ALERT SERVICE BULLETIN
REVISION NOTICE
Bell Helicopter **TEXTRON**
A Subsidiary of Textron Inc.

SUBJECT: REVISION "D" TO ALERT SERVICE BULLETIN 412-00-106 (TAIL ROTOR BLADE 212-010-750-009 THROUGH -129 TIP BLOCK MODIFICATION)

NO. 412-00-106

SUBJECT: TAIL ROTOR BLADE P/N 212-010-750-009
THROUGH -129, TIP BLOCK RETENTION
MODIFICATION

Figure 1
212-010-750 - ALL
TAIL ROTOR TIP RETENTION MOD

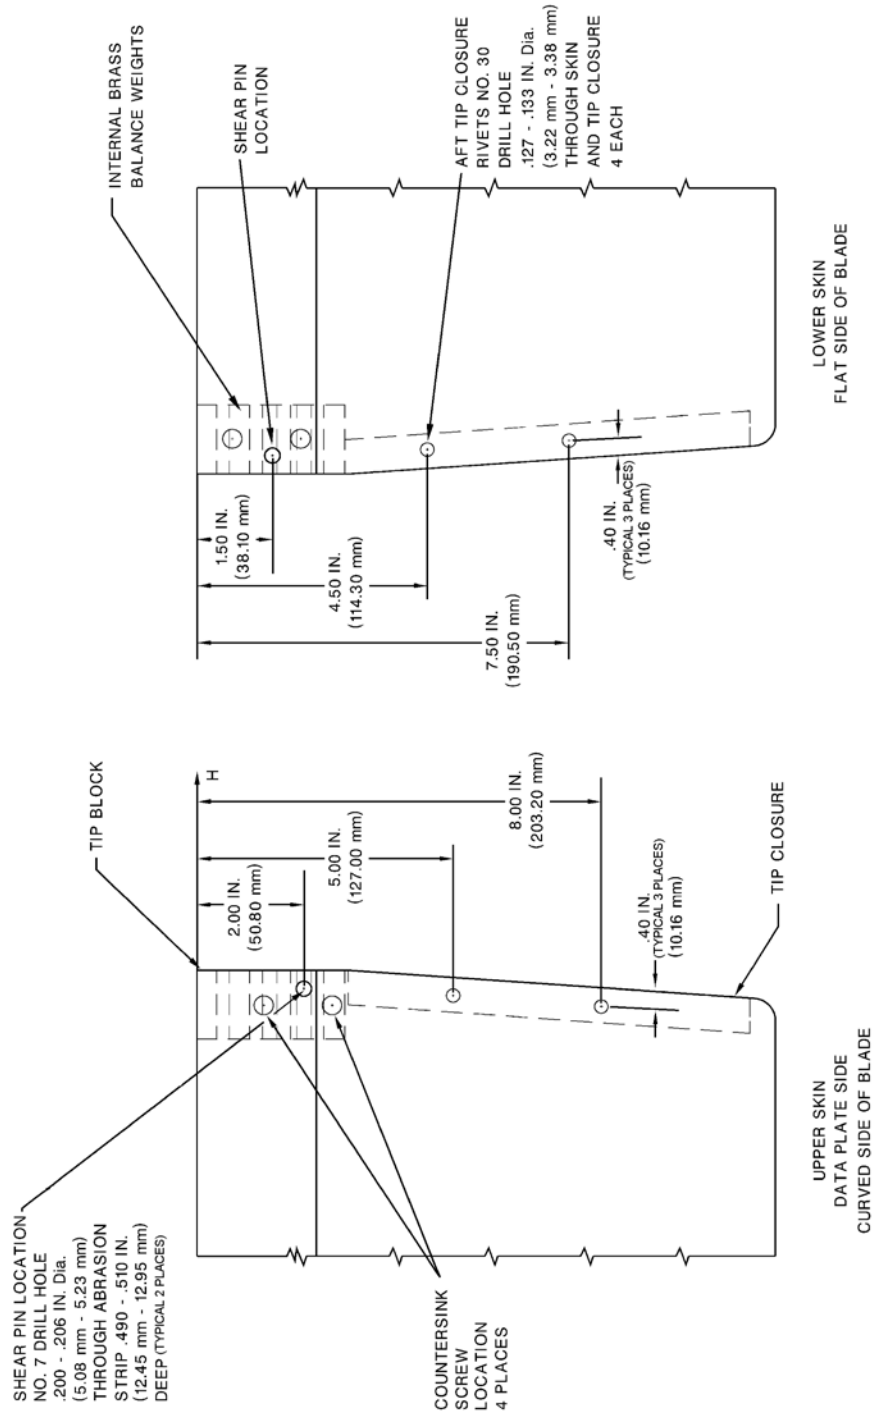
Revision "D" to this bulletin provides an alternate fastener for the tail rotor blade tip closure rivets installation.

This alternate rivet P/N NAS9307M-4-01 has a monel sleeve which is more erosion-resistant. Installation of this rivet with sealant MIL-PRF-81733 in lieu of adhesive 299-947-100 TY2 CL 2 will offer a better protection against water contamination and corrosion. An oversize rivet P/N NAS9310M-4-01 is also added to the material list.

1. Deleted
2. Inspect forward tip weight retention block and aft tip closure for voids. Remove any blade from service that exhibits voids in excess of CR&O limitations.
3. Inspect forward tip block attachment countersink screws. 4 locations. See Figure 1. Inspect to insure that the head of the countersunk screw is flush with the surface of the abrasion strip.
4. T/R blades that have the screws flush with the surface of the abrasion strip in all 4 locations do not require shear pin installation. T/R blades with one or more of the screws that are set below the surface of the abrasion strip or are covered with filler material may not provide acceptable retention of the tip block in the event of adhesive failure and will require shear pin installation. The limit is flush to 0.010 inch (0.0254 mm) high.
5. The aft tip closure rivet installation must be accomplished on all tail rotor blades.

1. Using a clean, sharp No. 7 drill bit, drill a **.50** inch deep shear pin installation hole as shown on Figure 1. The upper surface of the blade can be identified as the curved side of the blade and is same side as the data plate. Likewise the lower surface of the blade is the most flat side of the blade. The shear pin installation holes are located at 2.0 inches (projected) aft of the leading edge on the upper surface and 1.5 inches (projected) aft of the leading edge on the lower surface.

1. Using a clean, sharp no.30 drill bit, drill two rivet installation holes on both the upper and lower surface of the blade tip as shown in Figure 1. It is not necessary to remove the paint in the area.

2. De-burr drilled holes and verify rivet fit. Clean M7885/2-4-01 or NAS 9307M-4-01 rivets and drilled holes with Aliphatic Naphtha. Wipe dry before solvent evaporates.

3. Obtain a kit of sealant per MIL-PRF-81733. Thoroughly mix the accelerator, add it to the base product, then thoroughly mix the mixture until a uniform color, devoid of streaks, is achieved.

4. Coat rivet-shanks with MIL-PRF-81733 sealant and install verifying that rivet heads are seated firmly with blade skin. Allow a fillet of adhesive to squeeze out around rivet heads to insure blade is sealed.

5. Allow sealant to cure for 24 hours at room temperature. Refinish rivet heads in accordance with 412 MM for blade refinishing. Re-identify the modified blade by the addition of "FM" after the part number (i.e., 212-010-750-109FM).
